To: HPC  
From: HPC Staff  
Re: Reconsideration of HAWP #1028583  
12 E. Melrose St., Chevy Chase

To: HPC  
From: HPC Staff  
Re: 12 E. Melrose St., Chevy Chase  
HAWP #1028583

**MONTGOMERY COUNTY HISTORIC PRESERVATION COMMISSION**  
**STAFF REPORT**

<b>Address:</b>	12 East Melrose, Chevy Chase	<b>Meeting Date:</b>	4/26/2023
<b>Resource:</b>	Contributing Resource <b>Chevy Chase Village Historic District</b>	<b>Report Date:</b>	4/19/2023
<b>Applicant:</b>	Laura Braden	<b>Public Notice:</b>	4/12/2023
<b>Review:</b>	HAWP	<b>Tax Credit:</b>	N/A
<b>Permit Number:</b>	1028583	<b>Staff:</b>	Dan Bruechert
<b>Proposal:</b>	Fence Installation

Figure 2: Proposed fencing on-site - 6' fence shown in red, recommended limits outlined in blue.

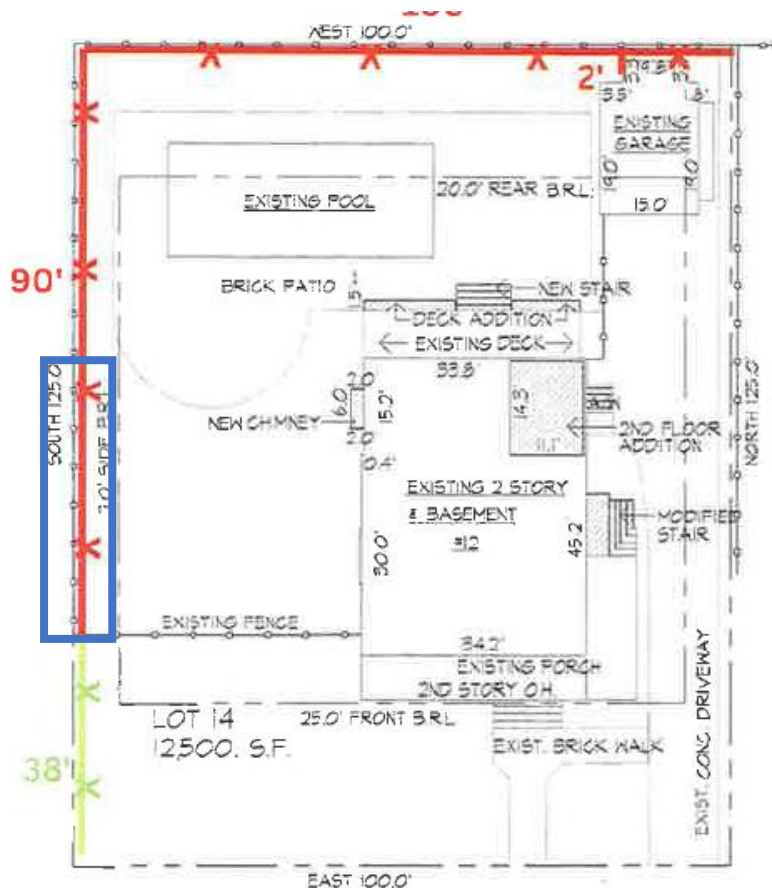
Staff finds the proposed 4' (four foot) tall picket fence matches the design, materials, and height of the neighboring fence and is compatible with the character of the district. The application does indicate a finish for the proposed fence. Staff finds a painted fence in the front yard is more compatible with the character of the site and district, and is consistent with the two adjacent fencings and recommends the HPC include a condition for approval that the proposed picket fence is painted to match the existing.

The HPC generally requires fences in the Chevy Chase Historic District that are forward of the rear wall plane to be no taller than 4' (four feet) and have an open picket design to preserve the district's character-defining, open park-like setting. In select instances, the HPC has allowed taller fences where there are needed to satisfy code requirements, but those fences also need to have an open picket character. Staff finds the proposed 6' (six foot) fence along the rear property line will not be visible from the public right of way and is appropriate under lenient scrutiny. Staff does not find all of the proposed solid board fencing along the left property boundary is compatible with the character of the district. While Staff finds a 6' (six foot) tall fence is consistent with the existing fence across the left side yard, the solid appearance does not contribute to the district's open, park-like setting. Several fence designs could be acceptable under the guidance. Staff recommends the HPC include a condition on the approval of this HAWP, requiring the fence along the left property line in front of the historic rear wall plane needs to have an open picket design and be painted. The approximate boundaries of Staff's recommendation are shown in *Fig. 2*, below). To the rear of the historic rear wall plane, the solid board fence is appropriate.

1. The proposed 4' picket fence needs to have a painted finish;
2. The fence along the left property boundary, in front of the rear wall plane, needs to have an open picket design and a painted finish;

Figure 2: Proposed fencing on-site - 6' fence shown in red, recommended limits outlined in blue.

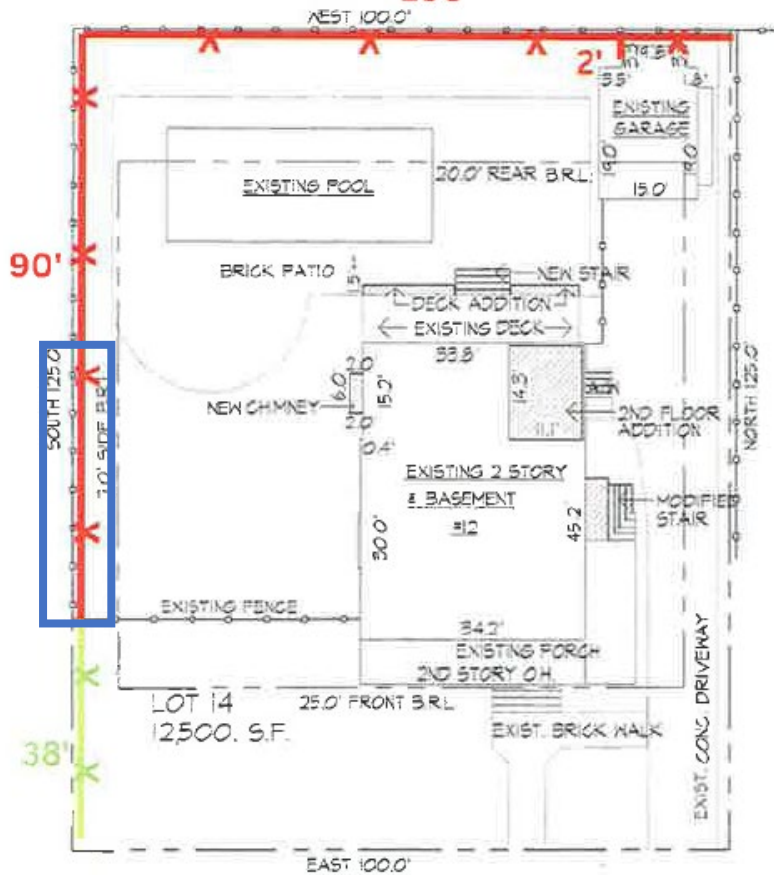
Staff finds the proposed 4' (four foot) tall picket fence matches the design, materials, and height of the neighboring fence and is compatible with the character of the district. The application does indicate a finish for the proposed fence. Staff finds a painted fence in the front yard is more compatible with the character of the site and district, and is consistent with the two adjacent fencings and recommends the HPC include a condition for approval that the proposed picket fence is painted to match the existing.

The HPC generally requires fences in the Chevy Chase Historic District that are forward of the rear wall plane to be no taller than 4' (four feet) and have an open picket design to preserve the district's character-defining, open park-like setting. In select instances, the HPC has allowed taller fences where there are needed to satisfy code requirements, but those fences also need to have an open picket character. Staff finds the proposed 6' (six foot) fence along the rear property line will not be visible from the public right of way and is appropriate under lenient scrutiny. Staff does not find all of the proposed solid board fencing along the left property boundary is compatible with the character of the district. While Staff finds a 6' (six foot) tall fence is consistent with the existing fence across the left side yard, the solid appearance does not contribute to the district's open, park-like setting. Several fence designs could be acceptable under the guidance. Staff recommends the HPC include a condition on the approval of this HAWP, requiring the fence along the left property line in front of the historic rear wall plane needs to have an open picket design and be painted. The approximate boundaries of Staff's recommendation are shown in *Fig. 2*, below). To the rear of the historic rear wall plane, the solid board fence is appropriate.

1. The proposed 4' picket fence needs to have a painted finish;
2. The fence along the left property boundary, in front of the rear wall plane, needs to have an open picket design and a painted finish;
